Access Compliance Report Public Rights-of-Way (Curb Ramps)

Main Street: PROSPECT_AVE Cross Street: ANGLIN_LN Location: SW

ADA ID: RPRK220127123105 Ramp Type: Type 4 - Parallel Initial Pass/Fail: Pass Overall Compliance: No Severity Score: 5

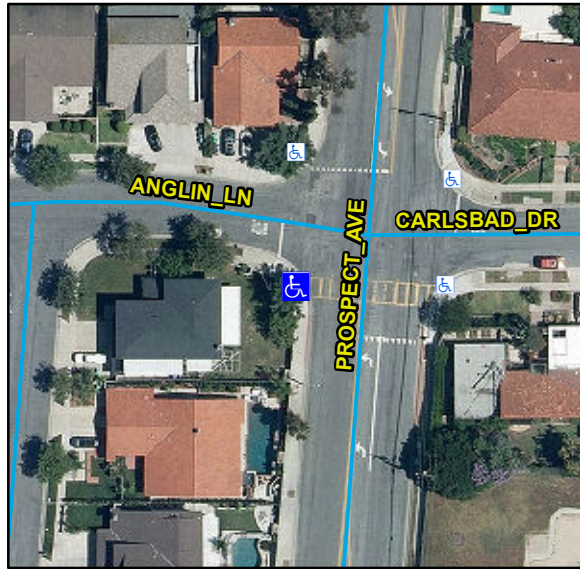
Crossing 1 Slope (%)	2.5		Crossing 2 Slope (%)	2.6
	Crossing 1 Cross Slope (%)	2.7		Crossing 2 Cross Slope (%)	1.7
Yes	Gutter Ponding	No	Yes	Curb Slope	2.1
Yes	Gutter Lip Height (in)	0		Road Run Slope (%)	1
No	Gutter Run Slope (%)	5.1		Road Cross Slope (%)	3.6
Yes	Gutter Cross Slope (%)	1.7	Yes	Perpendicular Joint Present	Yes
Yes	Overall Surface Condition	Acceptable			
	Cross Gutter Present?	No		Spandrel Present?	No
	Replace Cross Gutter?	N/A		Replace Spandrel?	N/A

Remove & Replace Gutter.

R304.5.4, STD 1115
